Appendix G Response to Comments:

A public hearing regarding the TMDL was held on November 15, 2016. Written comments were accepted through December 9, 2016. A complete listing of comments received during the public comment period is provided below as well as a response to the comment. Comments have been sorted into topic categories and have been numbered for reference. In most cases, the actual text submitted is used; however, in some cases what was submitted has been shortened to reflect the actual comments.

Germantown Power Plant
 Exhibit # 2A: Outfall Locations

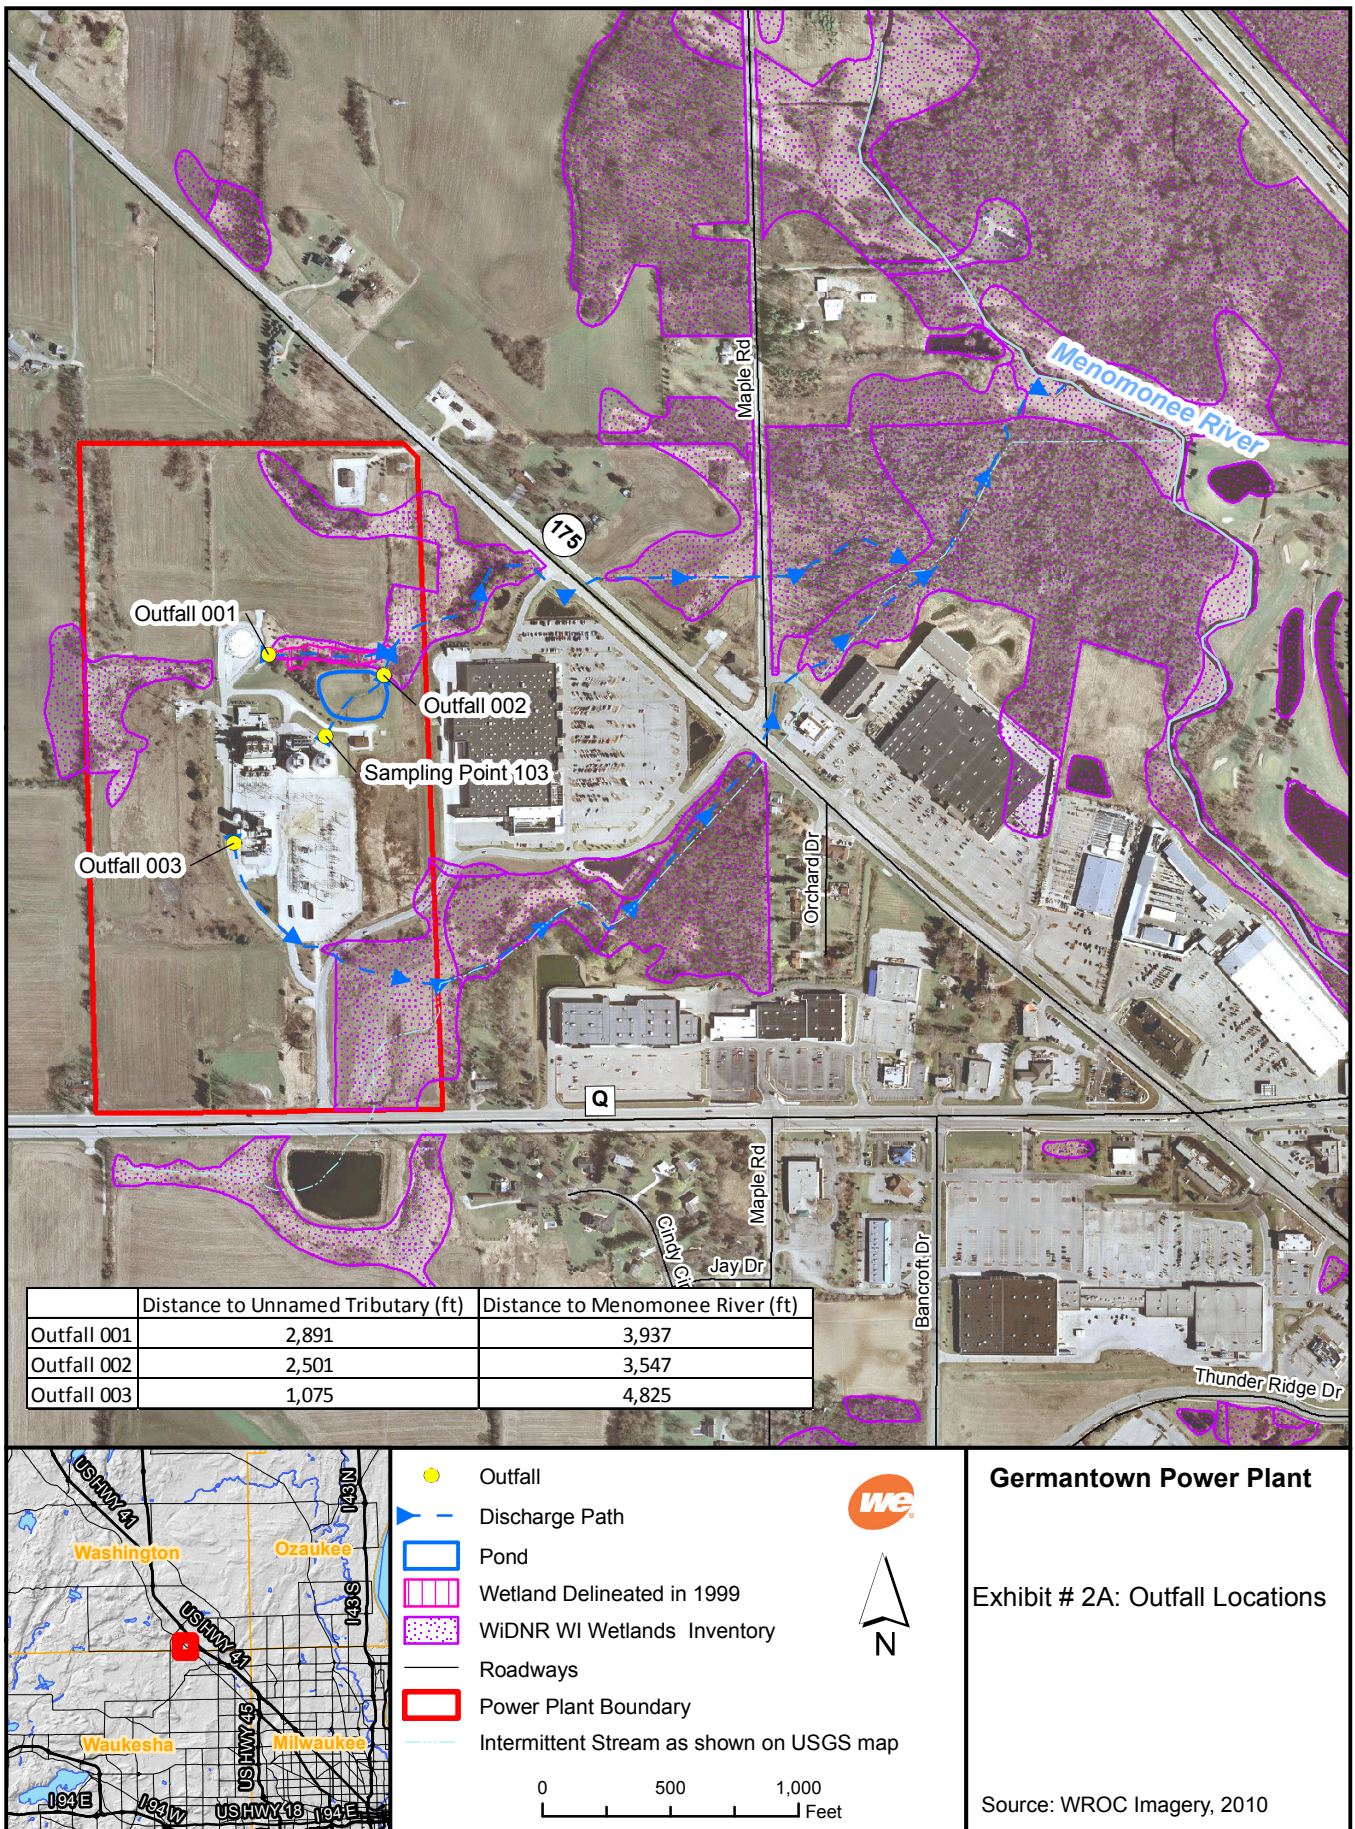
8. We request that the Department update the baseline flow for We Energies Germantown Outfall 003 to 0.003 MGD and the note on Table 4-1 to match the note specified for Arkema, Inc. We request that the Department update the baseline flow for We Energies Milwaukee Heating Plant outfalls as follows, and work with us to determine the appropriate baseline TP concentrations. The design flow rate for Outfalls 001, 002, and 003 is 0.108 MGD; for Outfall 004 is 0.072 MGD; and for Outfall 006 is 0.1296 MGD. (We Energies)

Response: The We Energies Germantown Outfall 003 has not had any discharge and any potential future discharge from this outfall is unlikely to leave the site as described in the permit. The TMDL and note on Table 4-1 is consistent with the permit. The note used for Arkema, Inc. is not applicable to outfall 003. Arkema's permit regulates a groundwater remediation system and a small amount of cooling water from groundwater. Arkema did not receive an allocation.

Figure 1. Kettle Moraine Springs State Fish Hatchery Outfall Location Map

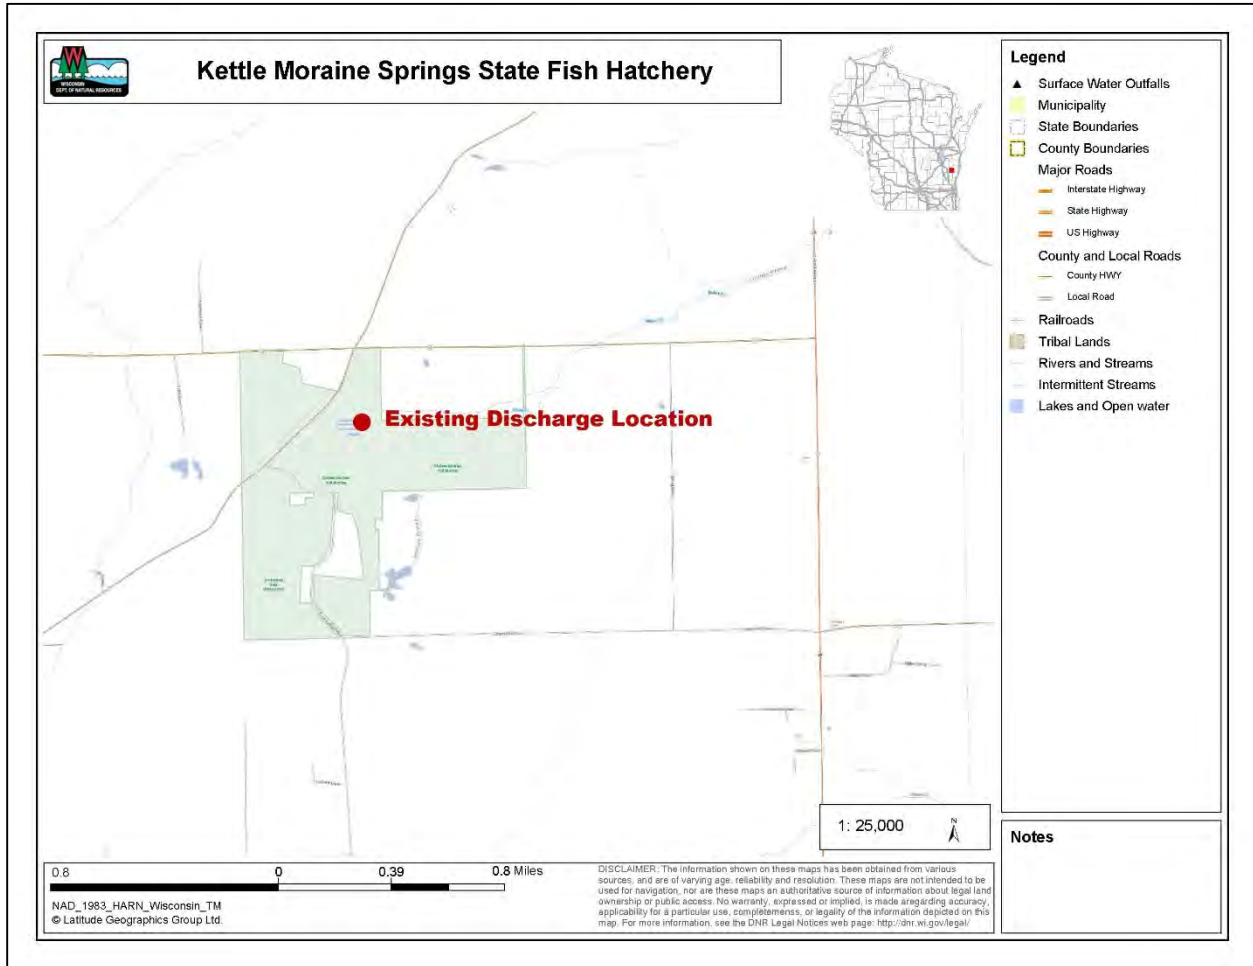
The Kettle Moraine Springs State Fish Hatchery (WPDES Permit No. WI-0026255) is in planning for a complete rebuild of existing infrastructure (groundbreaking planned for 2018). A Pre-Design Study is being finalized and includes recommendations for a new fish species hatchery aquaculture system, water supply facilities, wastewater treatment facilities, utilities, and buildings. As a result, the anticipated discharge flow rate is to be increased to 2.88 MGD, compared to the 1.2 MGD flow rate currently utilized in the draft Milwaukee River TMDL document.

We are requesting that the baseline flow information for outfall 001 be updated with the projected flow rate before the TMDL report is finalized. Updating the flow will accommodate the planned facilities flow rate, will likely prevent the need to submit a written notice of interest for reserve capacity, and will allow for a new or increased wasteload allocation.

Response: As of the drafting of the TMDL, plans for the Kettle Moraine facility have not been finalized. Potential flows for the facility range from potentially below what is assumed in the TMDL to the 2.88 MGD referenced in the comment. Consistent with TMDL development and reserve capacity practices, if the Kettle Moraine Springs Fish Hatchery does expand its discharge flows beyond the baseline assumptions used in the TMDL in the future, the facility can request reserve capacity as outlined in the TMDL.
